Service Bulletin B0203016 2002-05

Subject: Frame Electrical Ground.

Effected Model Numbers: All ZTH52 & ZTH61 Kawasaki Engine Equipped Gen II & XP Mowers.

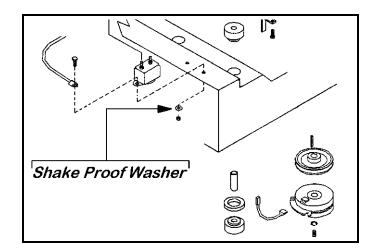
The frame to battery ground wire is fastened to the solenoid, located alongside the engine on the left side of the frame. There should be a "shake proof" washer between the nut and underside of the frame below the solenoid (see illustration). This washer is intended to cut through the paint and properly ground the frame to the battery negative post connection. Some of these shake proof washers may have been left off in production.

On units where there appears to be an electrical concern with frame grounded components, this frame wire connection should be checked. Along with installing a shake proof washer, it may be a good idea to remove some of the paint under the frame where the washer will seat, insuring a proper ground connection.

Parts Information: Any 1/4 inch internal or external "shake proof" washer can be used. These are available from most hardware stores, or can be ordered from Husqvarna under **P/N 539990053**.
